**Wake County Public School System  
HERITAGE HIGH SCHOOL  
CENTRAL PLANT REPLACEMENT**

**ADDENDUM NO. 2**

**DATE:** March 7, 2023

**1 MECHANICAL DEMOLITION PLAN**  
MD1.01 SCALE: 1/4" = 1'-0"  
NORTH

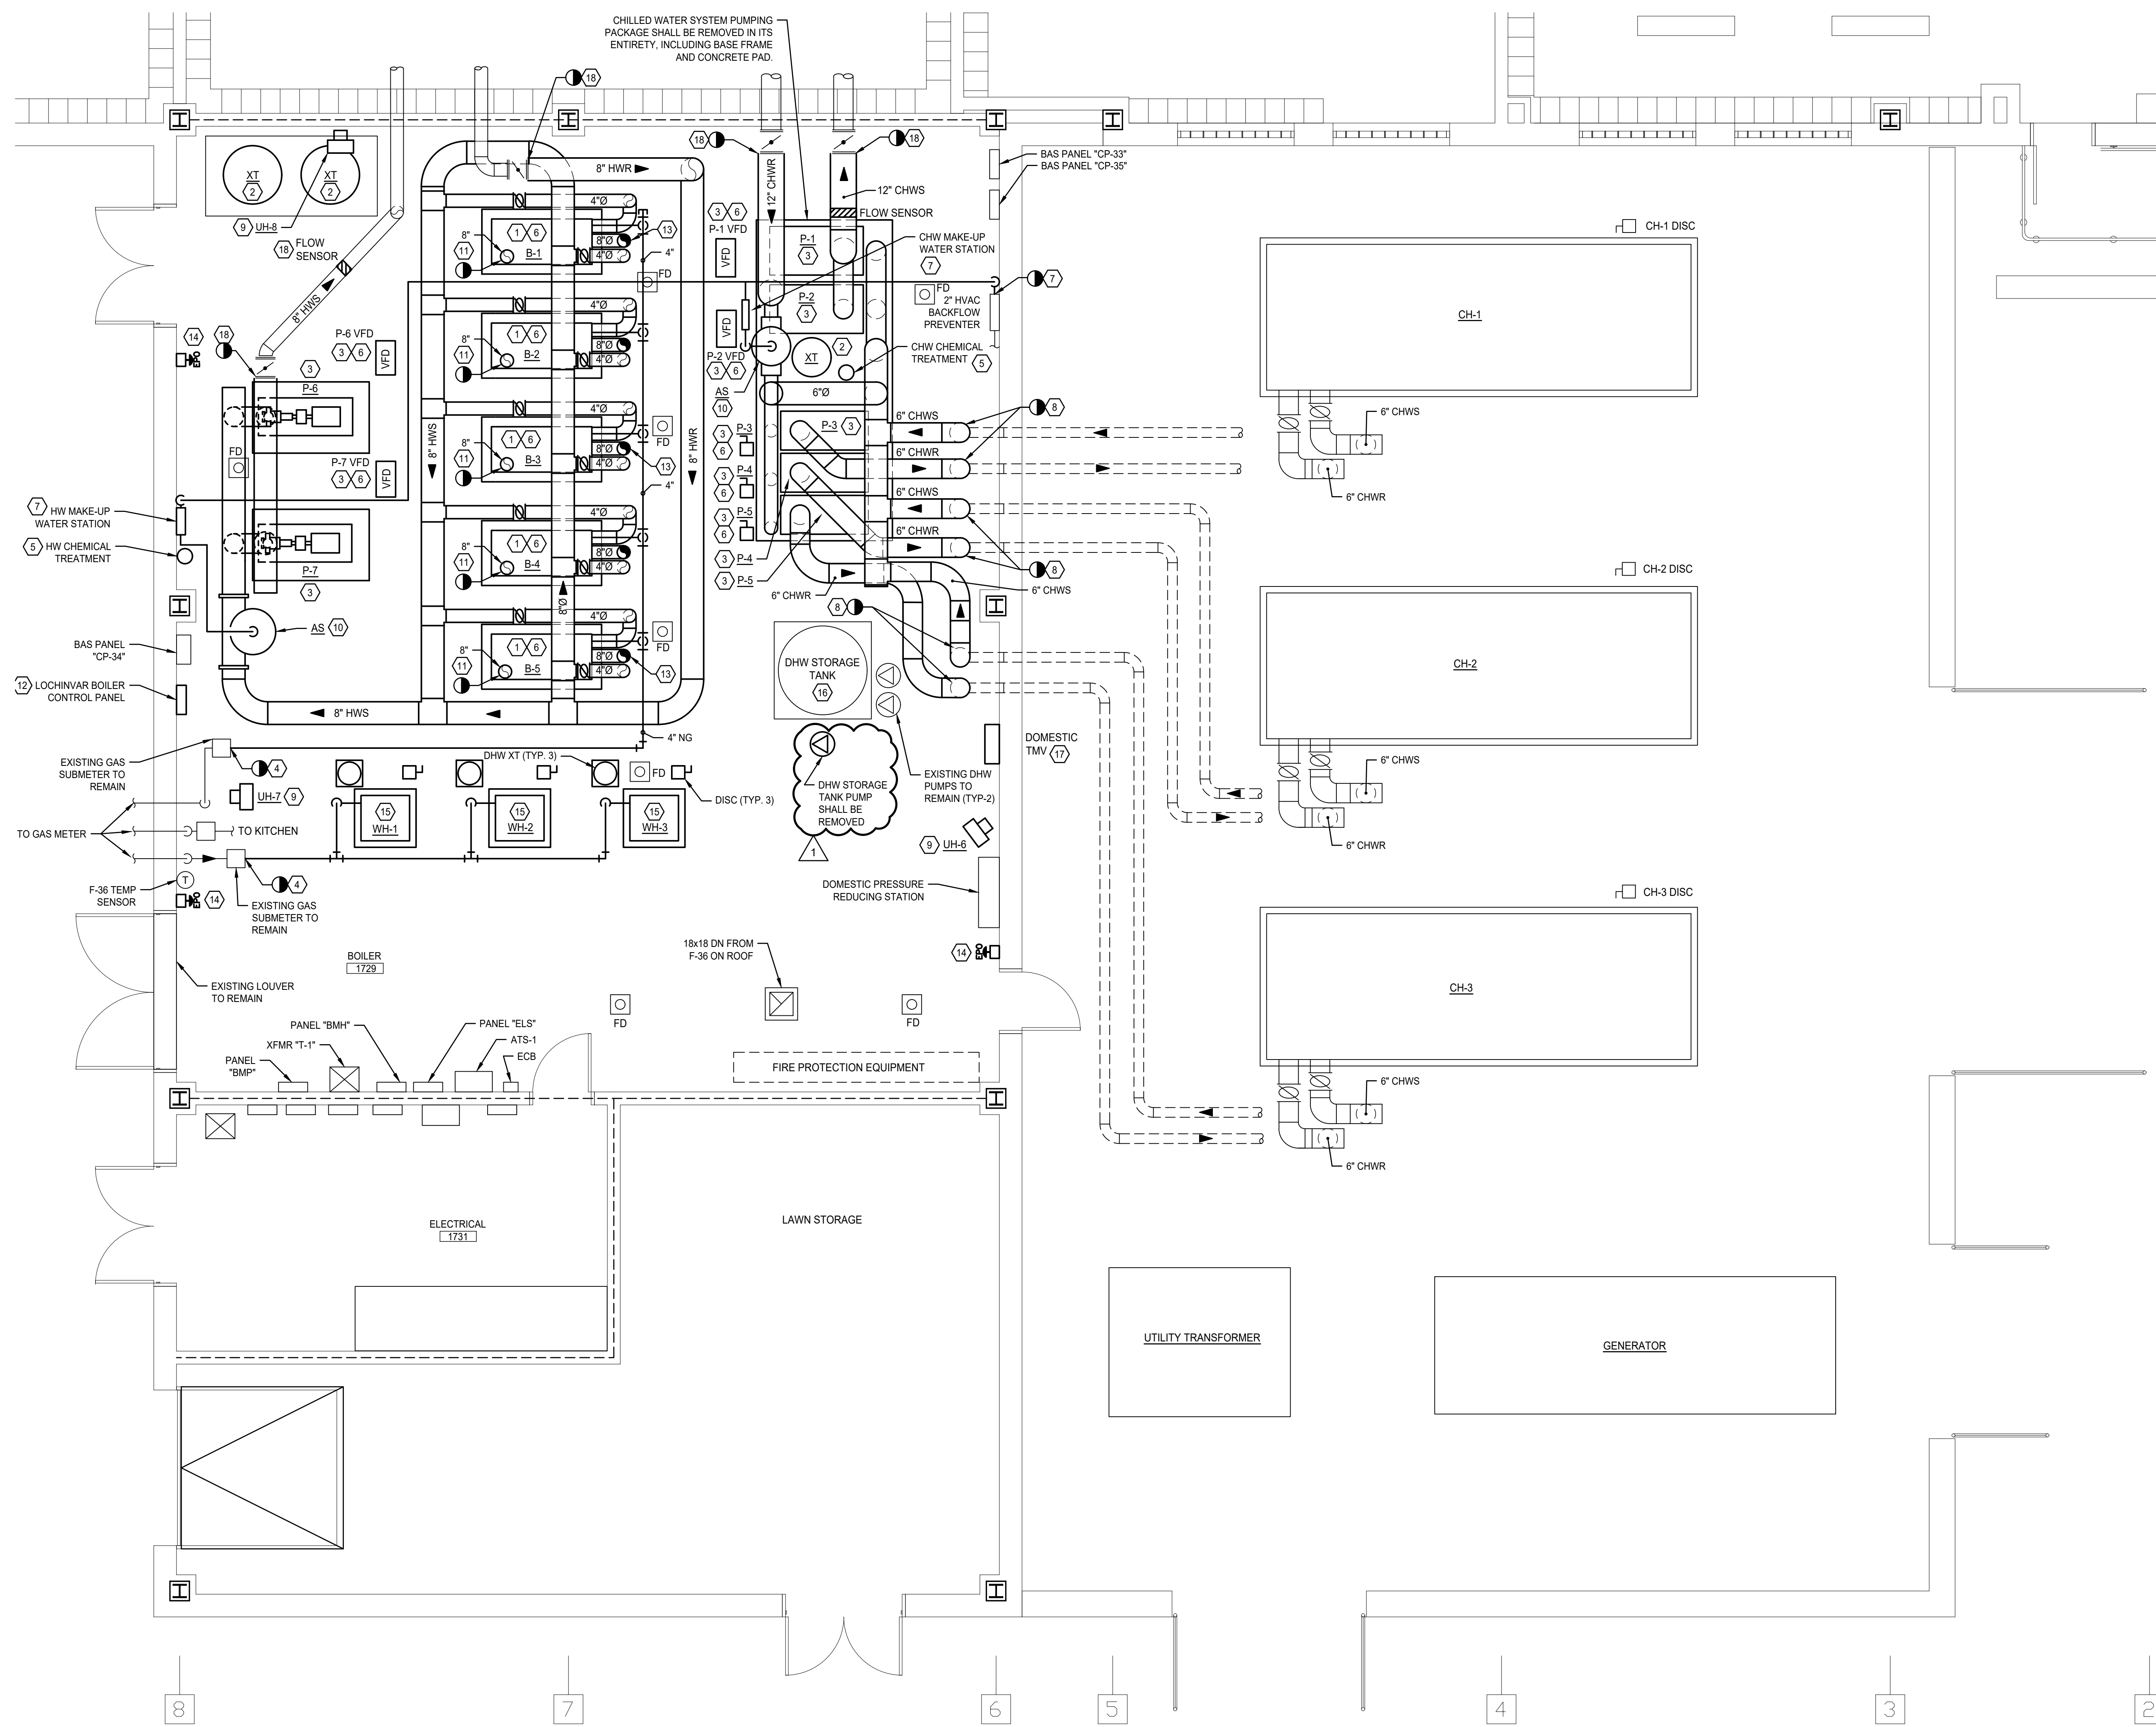
1. Sheet MD1.01 – Revised plan to add demolition scope for domestic water pump.
2. Sheet M1.01 – Revised plan to add piping scope for demolition of domestic water pump.
3. Sheet M6.01 – Revised water heater schedule to include pump sizing criteria.
4. Sheet ED1.01 – Remove circuit from pump demolished in mechanical changes, from equipment back nearest junction box, and mark as spare.
